# FAIRFAX COUNTY

## STAFF REPORT

APPLICATIONS RZ 2002-MV-020 and FDP 2002-MV-020  
and SE 2002-MV-022

SUMMIT OAKS

CHURCH- NORTH ELEVATION

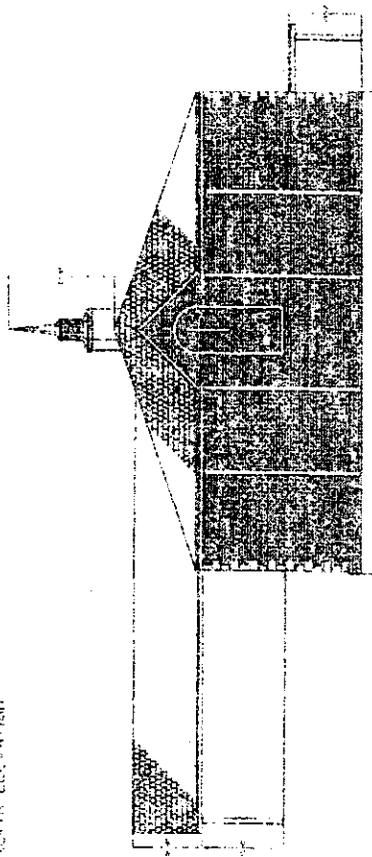
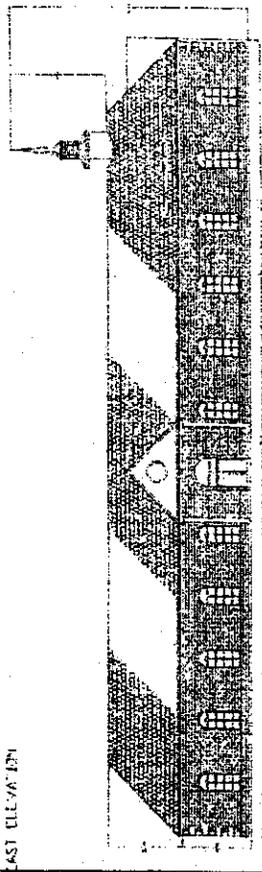
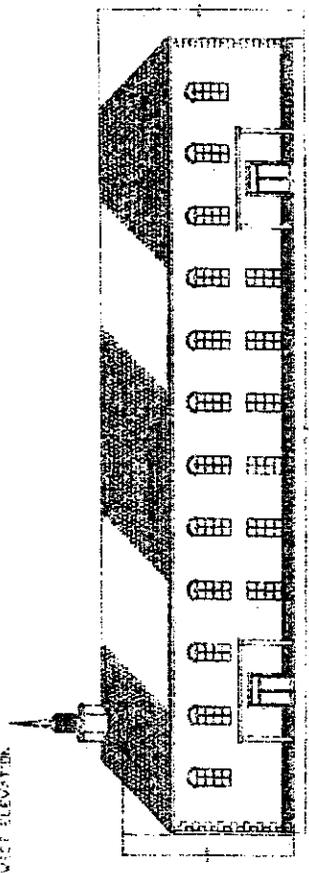
Sheet 10A contains elevations of the proposed church. Again, materials are not labeled; however, the north and east elevations, which are seen from Route 1 and the Pohick Church, respectively, appear to be brick. The west elevation, which faces the main parking lot, appears to have only a brick water table but the primary building material is not indicated. The applicant has proffered that the church will be in substantial conformance with the general character of the conceptual renderings shown on this plan sheet. As with the residences, the church architecture is subject to the review and approval of the ARB.

4. The design and architecture of the church shall be in substantial conformance with the general character of the conceptual renderings shown on Sheet 10A of the Plan. The four (4) units identified as "Pastoral Housing" on the Plan shall be designed with an architecture and materials that are compatible with the church structure, as determined by DPWES. It shall be further understood that final approval of the church architecture is subject to review and approval by the Architectural Review Board (ARB). This proffer shall not preclude implementation of the requirements of the ARB. Final ARB approval shall be obtained prior to the issuance of a building permit for any of the approved development on the R-3 zoned land.
